Title of Change:	MLP33 Case Outline Lead Length "L" and Lead DAP Length "G" Dimension Tolerance Change
Effective date:	01 Apr 2022
Contact information:	Contact your local onsemi Sales Office or Godfrey.Valles@onsemi.com
Type of notification:	This Product Bulletin is for notification purposes only. onsemi will proceed with implementation of this change upon publication of this Product Bulletin.
Change Category:	Documentation
Change Sub-Category(s):	Datasheet/Product Doc change

WDFN8 3.3x3.3, 0.65P
CASE 511DR
ISSUE A

Old Case Outline Drawing:

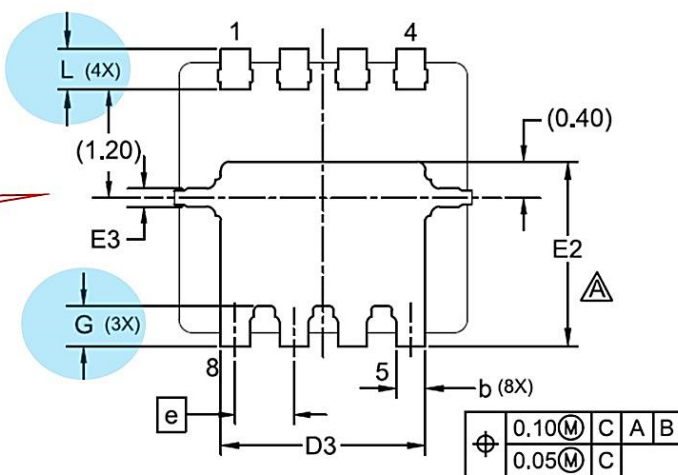
Changed Lead Length (dimension L) and Lead DAP Length (dimension G) to 0.40 +/- 0.10 mm (using JEDEC Standard Tolerance) of 511DR Case Outline. For Reference Case Outline/Dimension Alignment.
